WA/2022/01887 Land at Scotland Park, Midhurst Road, Haslemere

Further to our ongoing discussions and the completion of the Surrey County Council led Stage 1 Road Safety Audit, this letter presents our formal response (Designer's Response) to the Road Safety Audit (RSA) and provides confirmation on the remaining highway matters, including confirmation of the Applicant's willingness to agree to the financial contributions that have been requested by the Highway Authority.

**A286 MIDHURST ROAD
(NEAR D5524 SCOTLAND LANE)
HASLEMERE
PROPOSED GHOSTED RIGHT TURN LANE
JUNCTION AND SPEED MANAGEMENT
MEASURES**

**ROAD SAFETY AUDIT
STAGE 1**

Photo/Image 1.2

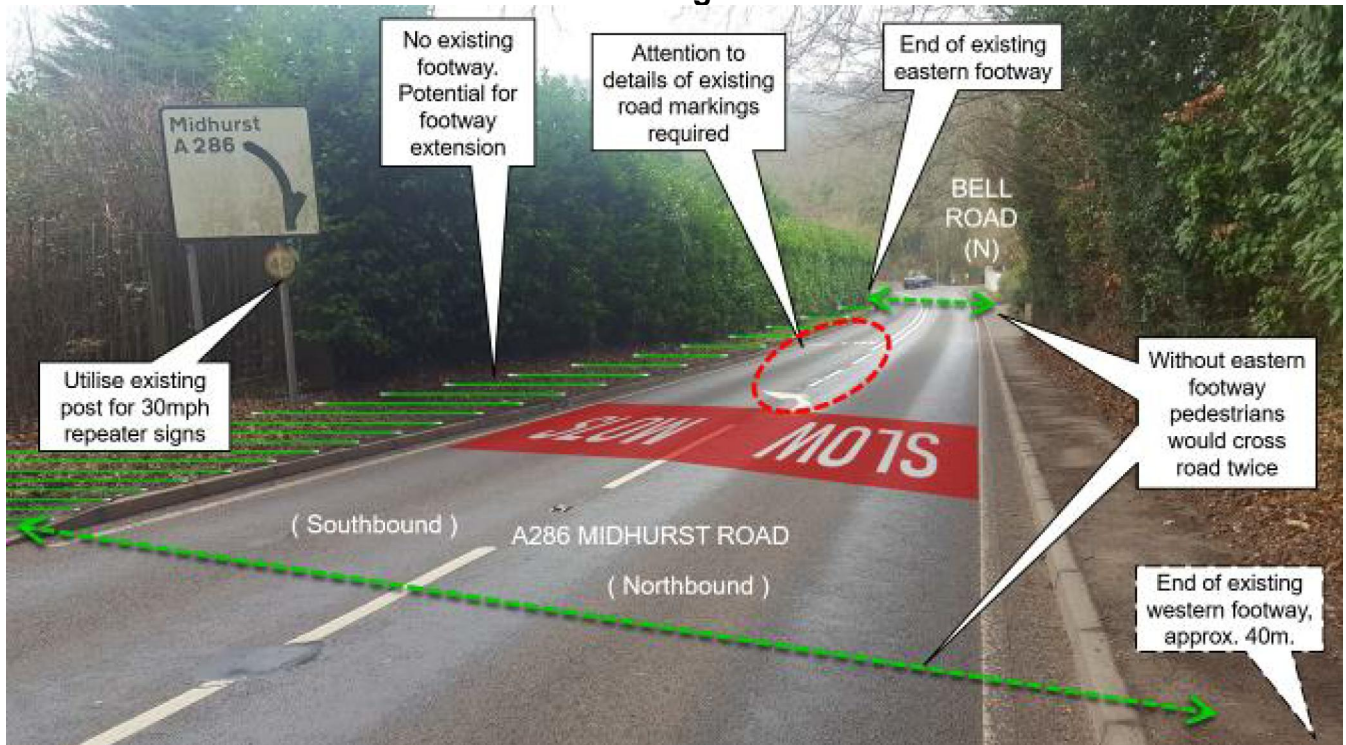
1.2 PROBLEM (Location: Appendix C-2 & Photo/Image 1.2, Dwg. No. 17054.024 Rev A, Sheet 8)

Summary: Risk of turning movement collisions, due to sign clutter and diminished perception of junction layout.

The proposed introduction of the 30mph speed limit from the Surrey county boundary, at the southern end of the scheme, coincides with an ADS depicting the A286 Midhurst Road/A287 Bell Road junction. The general location indicated for the proposed additional signage and road markings is shaded by trees, encroaching to the carriageway edge on the western side of the A286. With ADS, county boundary and other signs present, the visual impact of the entry to the 30mph area would be diminished. The additional signing may also detract from a driver’s perception of the A286/A287 junction layout on the northbound approach. These aspects would increase the risk of turning movement collisions at the nearby junction.

the existing ADS and the proposed 30mph terminal signs are positioned to be clear and distinct on northbound approach to the A286 Midhurst Road/A287 Bell Road junction;

the county boundary and any non-essential direction signs are moved or removed, to reduce sign clutter;

trees and vegetation shading the area proposed for the 30/40mph interface are cut back/removed to highlight signage and open up the view between the A286 Midhurst Road and A287 Bell Road junction approaches.

1.2	<p>(Location: Appendix C-2 & Photo/Image 1.2, Dwg. No. 17054.024 Rev A, Sheet 8)</p> <p>Summary: Risk of turning movement collisions, due to sign clutter and diminished perception of junction layout.</p> <p>The proposed introduction of the 30mph speed limit from the Surrey county boundary, at the southern end of the scheme, coincides with an ADS depicting the A286 Midhurst Road/A287 Bell Road junction. The general location indicated for the proposed additional signage and road markings is shaded by trees, encroaching to the carriageway edge on the western side of the A286. With ADS, county boundary and other signs present, the visual impact of the entry to the 30mph area would be diminished. The additional signing may also detract from a driver's perception of the A286/A287 junction layout on the northbound approach. These aspects would increase the risk of turning movement collisions at the nearby junction.</p>	<p>It is recommended that:</p> <ul style="list-style-type: none"> the existing ADS and the proposed 30mph terminal signs are positioned to be clear and distinct on northbound approach to the A286 Midhurst Road/A287 Bell Road junction; the county boundary and any non-essential direction signs are moved or removed, to reduce sign clutter; trees and vegetation shading the area proposed for the 30/40mph interface are cut back/removed to highlight signage and open up the view between the A286 Midhurst Road and A287 Bell Road junction approaches. 	<p>40 mph speed limit now retained. No changes to speed limit signs are now proposed.</p> <p>Sign clutter to be reviewed as part of the detailed design.</p> <p>Non-essential signs to be removed (subject to approval of SCC) as part of the detailed design.</p> <p>Vegetation to be cut back/removed.</p>

Photo/Image 1.5-1

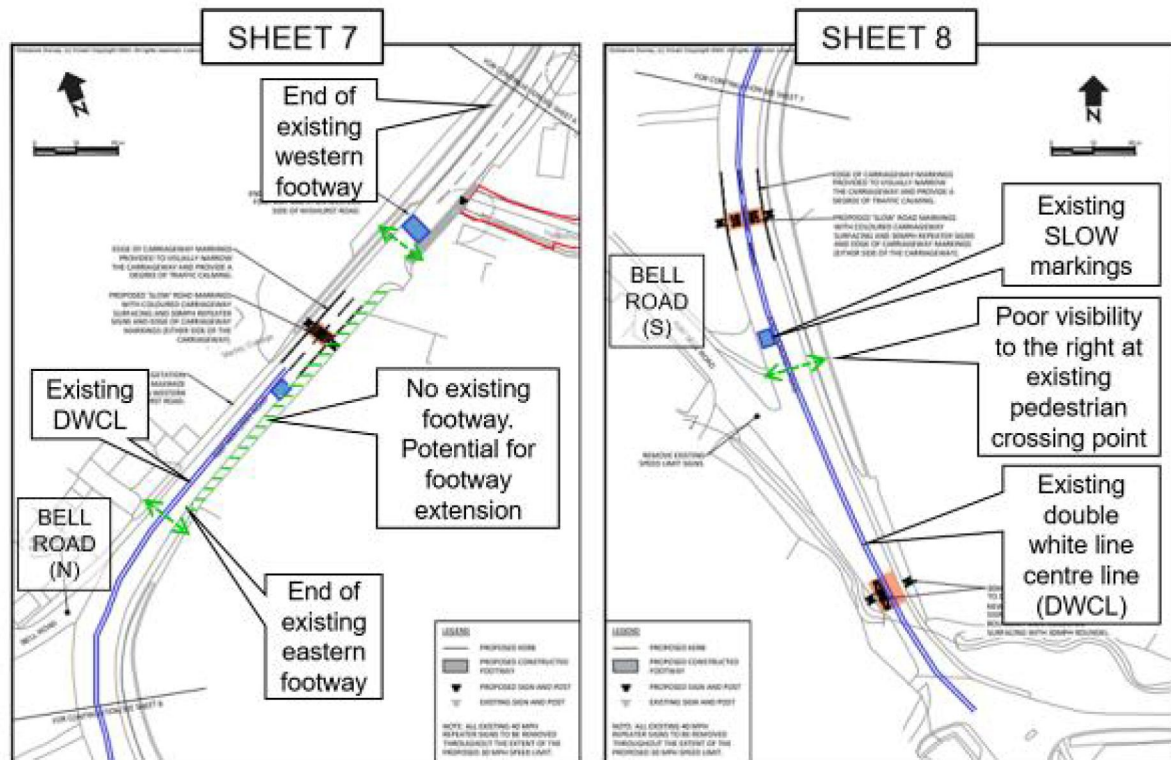
1.5 PROBLEM (Location: Appendix C-2 & Photo/Images 1.5-1 & 1.5-2, Dwg. No. 17054.024 Rev A, Sheets 7 & 8)

Summary: Risk of vehicle/pedestrian conflicts, due to lack of connectivity in footway provision.

The proposals include the provision of a short length of footway on the eastern side of A286 Midhurst Road just to the north of the access to Dene Meadows. This is shown to include tactile paving for an uncontrolled pedestrian crossing facility across the A286; inter-visibility to/from the north for pedestrians on the eastern side of the A286 is restricted by vertical and horizontal alignment. The existing footway on the western side of the road only extends as far as the Bell Road (N) junction to the south; there is no footway on the eastern side of the A286 over this length. This would result in pedestrians having to cross the road twice to follow a route between Dene Meadows (and the PRoWs FP597 and FP37) and points to the south. An existing uncontrolled pedestrian crossing facility across the A286 adjacent to the Bell Road (S) junction has poor visibility to the right for pedestrians crossing from east to west. The general poor provision for pedestrians would increase the risk of vehicle/pedestrian conflicts.

an additional length of footway is provided on the eastern side of A286 Midhurst Road, connecting Dene Meadows (and the adjacent PRoWs FP597 and FP37) to the existing eastern footway at the A286 j/w Bell Road (N) link; i.e. a new footway length of approximately 85m;

the proposed uncontrolled pedestrian crossing point immediately adjacent to Dene Meadow is removed from the proposals and replaced by a crossing point midway between Dene Meadow and the A286 j/w Bell Road (N) link;

vergeside trees and shrubbery on the eastern side of the A286 are cut back/removed to expose improved visibility for the existing pedestrian crossing route immediately to the north of the A286 j/w Bell Road (S) link;

existing road markings associated with the current double white line centreline system are reinstated or adjusted as appropriate to new road marking installations;

the positioning of existing SLOW markings is taken into account in developing the new road marking proposals and the sequence of markings is rationalised to avoid over-use, and;

existing sign posts are utilised wherever possible for the mounting of 30mph repeater signs, to maximise the available footway width.

- An additional length of footway is provided on the eastern side of A286 Midhurst Road, from Footpath FP37 to the existing eastern footway provision (to the south) on the eastern side of the A286 by its junction with Bell Road (N) [Refer to Drawing 17054-024 Rev C].

- The proposed uncontrolled pedestrian crossing point immediately adjacent to Dene Meadow has been repositioned to a point midway between Dene Meadow and the A286 j/w Bell Road (N) [Refer to Drawing 17054-024 Rev C].

Photo/Image 1.6

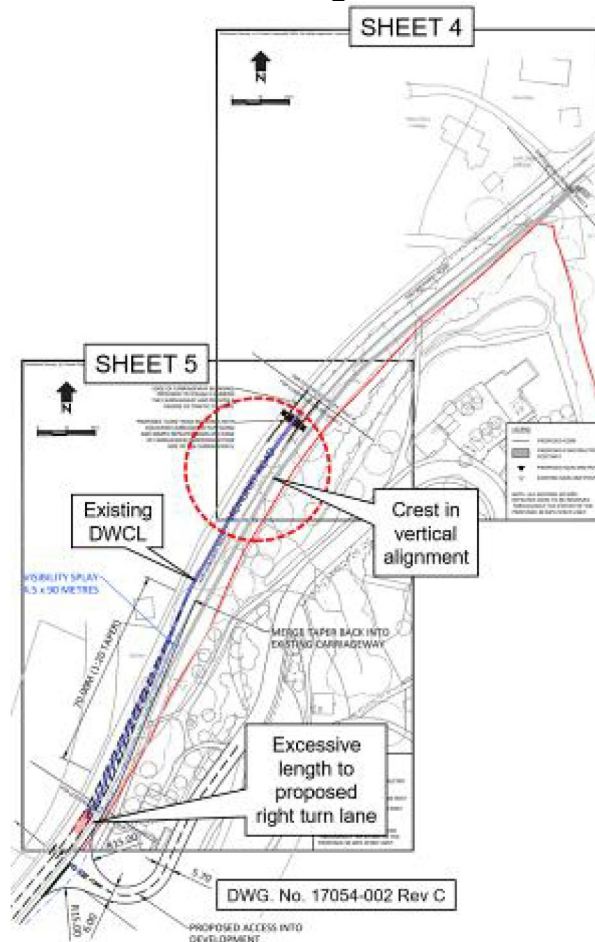
1.6 PROBLEM (Location: Appendix C-1 & Photo/Image 1.6, Dwg. Nos. 17054.024 Rev A, Sheet 6 & 17054.002 Rev C)

Summary: Risk of rear-end shunt and front-to-side impact type collisions, due to slow moving vehicles entering and exiting

The layout of the proposed ghosted right turn lane junction is based on the absolute minimum taper lengths appropriate to 85th percentile speeds of up to 30mph (1:20). Further to the issue raised at Item 1.1 above, recorded 85th percentile speeds from the ATC data provided are all in excess of 40mph. Given the curved alignment of the A286 in the vicinity of the proposed junction, short taper lengths would result in abrupt steering adjustments that create an increased risk of rear-end shunt type collisions between vehicles entering the right turning lane and passing traffic. The curved alignment also results in trees and shrubbery on the west side of the A286 obscuring the forward view for northbound drivers, potentially increasing the risk of front-to-side impact collisions as vehicles exit the proposed side road junction. It was noted that an existing junction ahead warning sign, relating to the northbound approach to the Scotland Lane/A286 Midhurst Road junction, was lying demolished on the western verge and that there is a significant downslope in the embankment on that side of the A286.

the taper lengths and overall junction layout is appropriate to achievable 85th percentile speeds;

traffic islands equipped with appropriate signage are provided within the central hatched areas on the junction approaches;

trees and shrubbery on the west side of the A286 is cleared to improve forward visibility through the junction;

the advance warning sign (currently demolished) relating to the northbound approach to the Scotland Lane junction is re-sited and erected a suitable distance from that junction, so as not to be confused with the new junction location, and;

hazard marker posts are provided in the western verge to improve delineation of the curve and aid the perception of northbound vehicle approach speeds for drivers exiting the development access road.

1.6	<p>(Location: Appendix C-1 & Photo/Image 1.6, Dwg. Nos. 17054.024 Rev A, Sheet 6 & 17054.002 Rev C)</p> <p>Summary: Risk of rear-end shunt and front-to-side impact type collisions, due to slow moving vehicles entering and exiting proposed junction.</p> <p>The layout of the proposed ghosted right turn lane junction is based on the absolute minimum taper lengths appropriate to 85th percentile speeds of up to 30mph (1:20). Further to the issue raised at Item 1.1 above, recorded 85th percentile speeds from the ATC data provided are all in excess of 40mph. Given the curved alignment of the A286 in the vicinity of the proposed junction, short taper lengths would result in abrupt steering adjustments that create an increased risk of rear-end shunt type collisions between vehicles entering the right turning lane and passing traffic. The curved alignment also results in trees and shrubbery on the west side of the A286 obscuring the forward view for northbound drivers, potentially increasing the risk of front-to-side impact collisions as vehicles exit the proposed side road junction. It was noted that an existing junction ahead warning sign, relating to the northbound approach to the Scotland Lane/A286 Midhurst Road junction, was lying demolished on the western verge and that there is a significant downslope in the embankment on that side of the A286.</p>	<p>It is recommended that:</p> <ul style="list-style-type: none"> the taper lengths and overall junction layout is appropriate to achievable 85th percentile speeds; traffic islands equipped with appropriate signage are provided within the central hatched areas on the junction approaches; trees and shrubbery on the west side of the A286 is cleared to improve forward visibility through the junction; the advance warning sign (currently demolished) relating to the northbound approach to the Scotland Lane junction is re-sited and erected a suitable distance from that junction, so as not to be confused with the new junction location, and; hazard marker posts are provided in the western verge to improve delineation of the curve and aid the perception of northbound vehicle approach speeds for drivers exiting the development access road. 	<p>Taper lengths and junction layout is appropriate for 70 kph (43 mph) design speed (as per CD123)</p> <p>Traffic Islands added to design</p> <p>Vegetation and shrubbery to be cut back to highway boundary to improve forward visibility.</p> <p>Advance warning sign relocated.</p> <p>Hazard marker posts added.</p>

Photo/Image 1.7-2

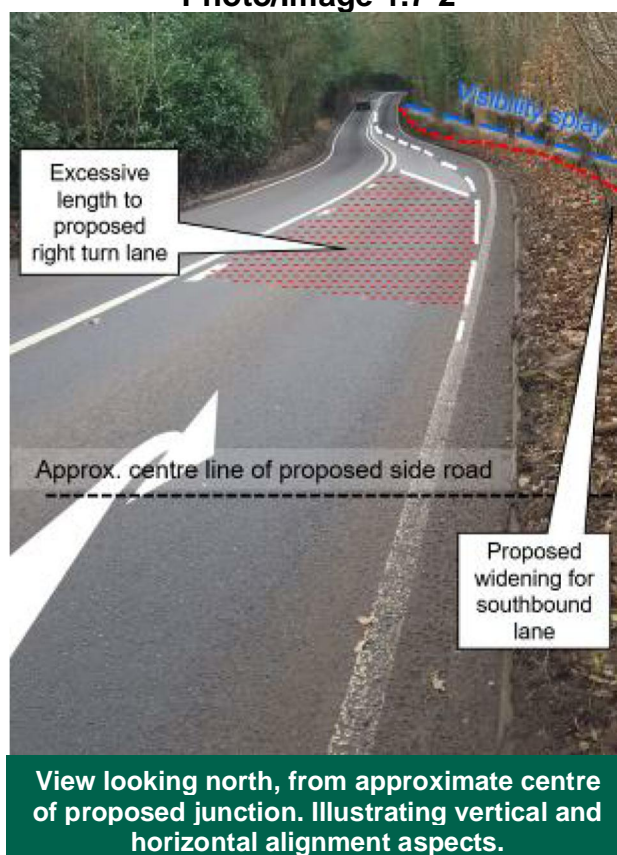
1.7 PROBLEM (Location: Appendix C-1 & Photo/Images 1.7-1 & 1.7-2, Dwg. Nos. 17054.024 Rev A, Sheets 4 & 5, & 17054.002 Rev C)

Summary: Risk of head-on and front-to-side impact type collisions, due to lack of driver perception of junction layout.

The horizontal and vertical alignment of the A286 Midhurst Road to the north of the proposed development access junction location warrants a double white line centre line on account of reduced visibility. This double white line system was extended northwards within the last 18 months, encompassing a crest, to end at a location that is more or less coincident with the proposed SLOW markings some 130m south of the Scotland Lane junction. The hatched ghosted island markings proposed for the development access junction are shown to be flanked by a dashed white line system and

the right turn lane extends beyond the optimal turning point. These aspects may result in attempted overtaking manoeuvres overriding the hatched area, especially by motorcyclists, and an increased risk of head-on and front-to-side impact collisions.

the forward visibility aspects in relation to horizontal and vertical alignment, visibility splays and driver perception of the junction layout on the southbound approach are verified, adding detail of proposals for verge-side and embankment clearance;

the white line system outlining the hatched area and turning length of the ghosted right turn lane junction is appropriate to the horizontal and vertical alignment aspects of the southbound approach to the proposed junction;

advance warning signs for the proposed side road junction are provided for both approach directions, and;

an advance warning sign depicting double bends ahead is provided facing southbound drivers at a suitable location prior to the start of the double white line system on the approach to the proposed junction.

- The double white line centreline system has been reinstated and adjusted as appropriate to accommodate the new site access and road markings [Refer to Drawings 17054-002 Rev E and 17054-024 Rev C].

- Traffic islands have been added to hatching that forms the ghosted right turn facility. Central hatching adjusted. [Refer to Drawings 17054-002 Rev E and 17054-024 Rev C].

Photo 1.8

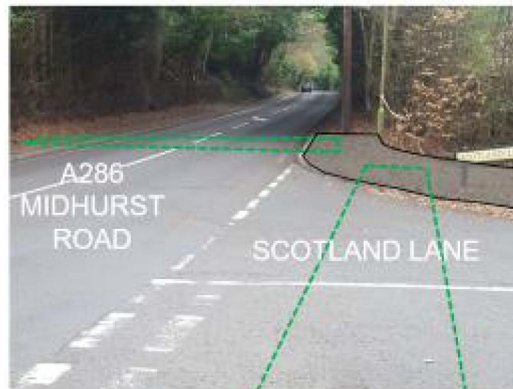
1.8 PROBLEM (Location: Appendix C-1 & Photo 1.8, Dwg. No. 17054.024 Rev A, Sheet 3)

Summary: Risk of incidents resulting from excessive speed, due to confusion of speed limits.

The proposals do not indicate the necessary amendments to existing speed limit signing at the Scotland Lane junction with A286 Midhurst Road. This may result in excessive speeds on Midhurst Road and increase the risk of speed related incidents.

It is recommended that detail is added to the proposals to include all corresponding amendments to speed limit signing.

1.8	<p>(Location: Appendix C-1 & Photo 1.8, Dwg. No. 17054.024 Rev A, Sheet 3)</p> <p>Summary: Risk of incidents resulting from excessive speed, due to confusion of speed limits.</p> <p>The proposals do not indicate the necessary amendments to existing speed limit signing at the Scotland Lane junction with A286 Midhurst Road. This may result in excessive speeds on Midhurst Road and increase the risk of speed related incidents.</p>	<p>It is recommended that detail is added to the proposals to include all corresponding amendments to speed limit signing.</p>	<p>Speed limit now retained as existing.</p>

Photo 1.10

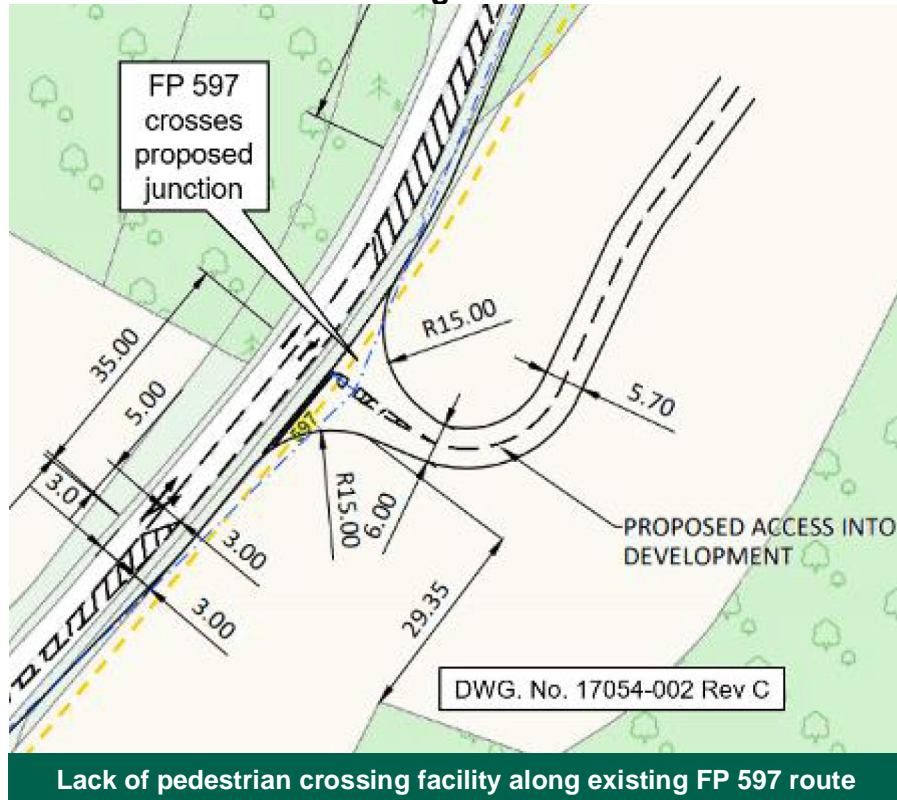
1.10 PROBLEM (Location: Appendix C-2 & Photo 1.10, Dwg. No. 17054.024 Rev A, Sheet 3)

Summary: Risk of incidents resulting from excessive speed, due to confusion of speed limits.

There is an existing VAS facing southbound A286 Midhurst Road traffic adjacent to the junction with Medowlands Drive and warning of the approach to the "Side Road Ahead" at Scotland Lane. The sign would currently be calibrated to the existing 40mph speed limit. Speeds in excess of the proposed 30mph limit would increase the severity risks of incidents at the Scotland Lane junction and beyond.

It is recommended that the existing VAS is retained and re-calibrated to the proposed 30mph speed limit.

1.10	<p>(Location: Appendix C-2 & Photo 1.10, Dwg. No. 17054.024 Rev A, Sheet 3)</p> <p>Summary: Risk of incidents resulting from excessive speed, due to confusion of speed limits.</p> <p>There is an existing VAS facing southbound A286 Midhurst Road traffic adjacent to the junction with Medowlands Drive and warning of the approach to the "Side Road Ahead" at Scotland Lane. The sign would currently be calibrated to the existing 40mph speed limit. Speeds in excess of the proposed 30mph limit would increase the severity risks of incidents at the Scotland Lane junction and beyond.</p>	It is recommended that the existing VAS is retained and re-calibrated to the proposed 30mph speed limit.	<p>40 mph speed limit retained.</p> <p>VAS retained as existing.</p>

Drawn AS	Designed SP	Date JAN 2018	Scale 1:1000	Size A3
Drawing No. 17054-002				Rev E

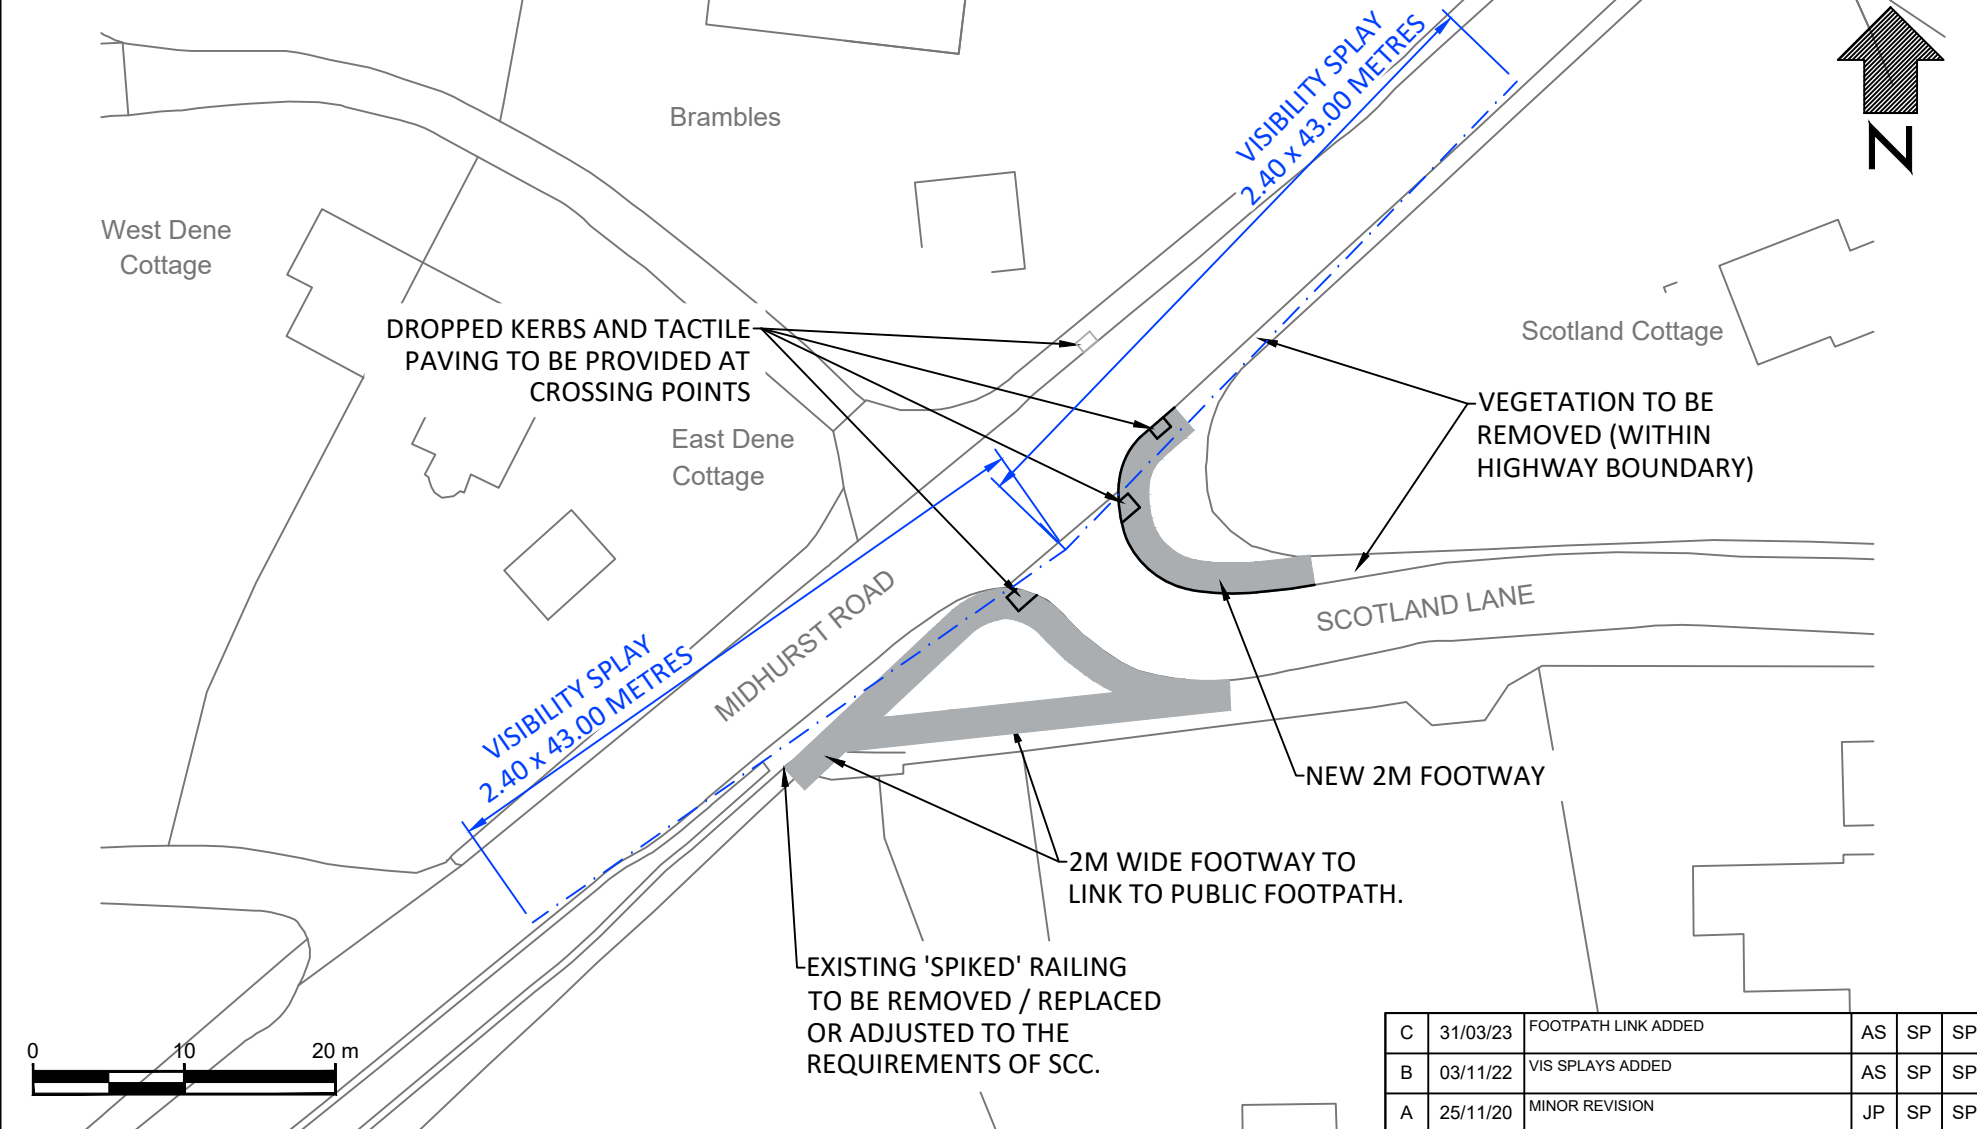
1.12 PROBLEM (Location: Appendix C-1, Dwg. No. 17054.002 Rev C)

Summary: Risk of fast entry speeds at proposed junction resulting on loss of control, due to wide entry/exit radii.

The 15-metre entry radius as proposed for the development junction access is likely to allow fast entry speeds. Due to the proposed alignment on entry, especially by southbound vehicles, there is a

risk of loss of control and / or over-turning. Also, vehicles exiting the proposed development would be able to align two-abreast which is likely to affect visibility of adjacent drivers of approaching A286 traffic.

the junction radii are reduced to an appropriate level according to the proposed development size, and;

- A reduction in kerb radii, for the site access, from 15 metres to 10 metres (to provide greater control of vehicular speeds on entry into the site access). [Refer to Drawings 17054-002 Rev E and 17054-024 Rev C].
